# SPECIAL MEETING GEORGETOWN-SCOTT COUNTY PLANNING COMMISSION AGENDA FEBRUARY 11, 2021 6:00 p.m.

# Staff Report to the Georgetown-Scott County Planning Commission February 11, 2021

Figure 1

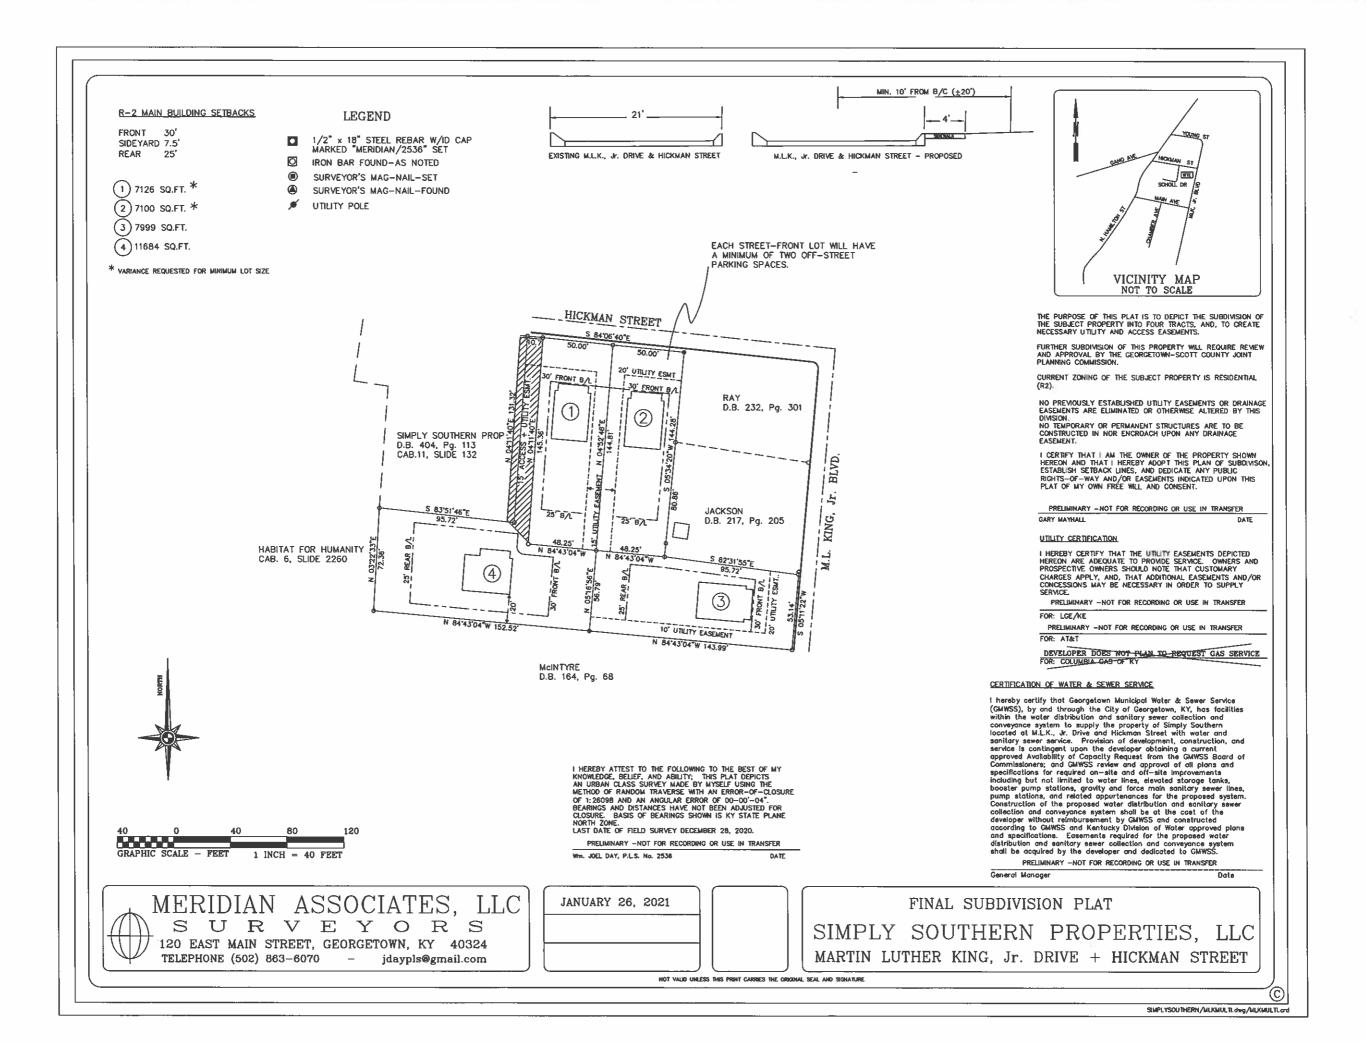
Most of the concerns that staff has with this application surround Lot 4. This lot has 10 feet of road frontage on Hickman Street, and the plat seeks to combine this with an access easement on the property to the west for a 15 feet wide access and utility easement. This is to provide access to a lot which, if this application is approved, will sit in the middle of the block surrounded by other houses and lots. It would create an odd or uncomfortable situation where the front of the house on Lot 4 would face the rear of one or more houses.

Staff has spoken to the Fire Department about the access to Lot 4. The Fire Department does not think that the 15 feet of width will be sufficient for their vehicles to provide fire protection. The Fire Department is also concerned that part of the width of the access relies upon an easement from a neighboring property, which may not always be kept clear for emergency access.

Georgetown Municipal Water and Sewer Service does not support the shared access and utility easement for Lot 4. GMWSS does not want the water meter and sewer cleanout located in the driveway/access easement.

Planning Commission Staff and the Comprehensive Plan support the creation of Lots 1-3. Staff does not support the creation of Lot 4. It is out of character with other properties in the area. It will reduce the privacy enjoyed by residents in the area to have a house facing the rear of their homes and backyards. It is not supported by the Fire Department or GMWSS. The best solution for the applicant is to split up what would have been Lot 4 and consolidate it with Lot 1 and the applicant's properties at 301 & 305 Hickman Street. Below, Figure 1 shows staff's recommendation.

Staff recommends **approval** of Lots 1, 2, and 3 and the variances listed below. Staff recommends **denial** of Lot 4. Should the Planning Commission approve the application, staff recommends including the following conditions of approval:

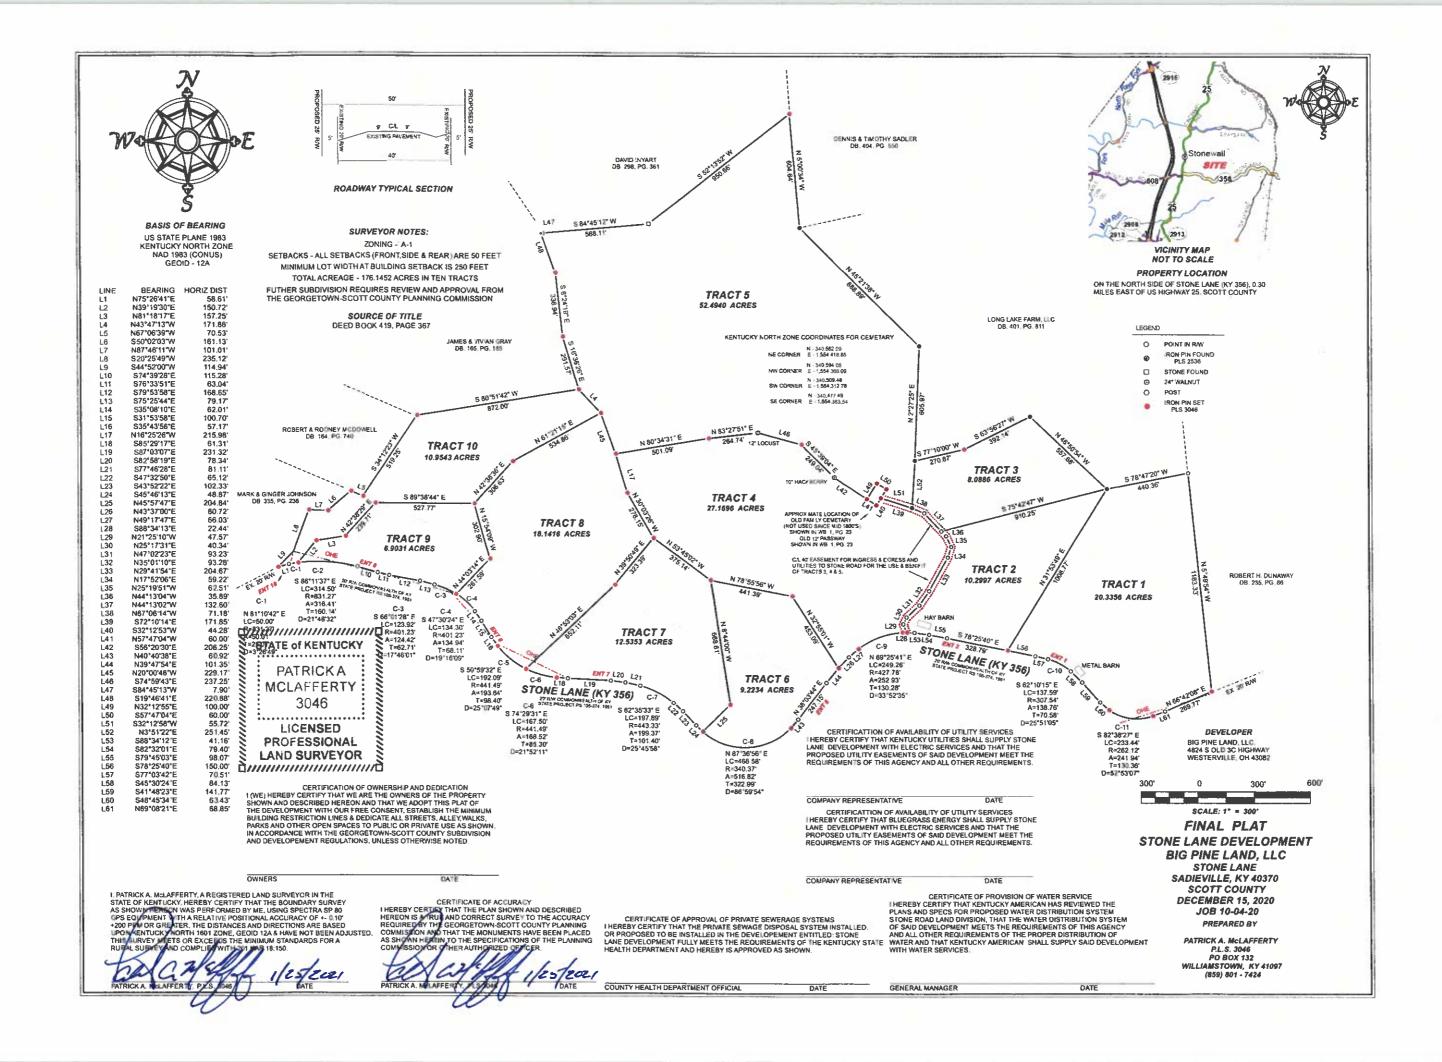
The Access easement proposed by this plat needs to be removed from Tract 2. Tract 2 is not being served by this access easement and would put the easement over the maximum of 3 established by the *Subdivision & Development Regulations*. Staff had mentioned during the TRC meeting that this access easement needed to be removed from Tract 2 to bring the plat into compliance

- 1. All applicable requirements of the Zoning Ordinance and Subdivision & Development Regulations.
- 2. Any revisions or amendments to the approved Preliminary Subdivision Plat shall be reviewed and approved by the Planning Commission staff (minor) or by the Planning Commission (major).
- 3. Prior to (as part of) the Final Subdivision Plat approval, the applicant shall provide the Planning Commission staff (GIS division) with a digital copy of the approved plat.
- 4. This Preliminary Subdivision Plat approval is valid for two years, subject to the requirements of Article 306 section A of the *Subdivision and Development Regulations*.
- 5. The proposed access easement shall not be on Tract 2.
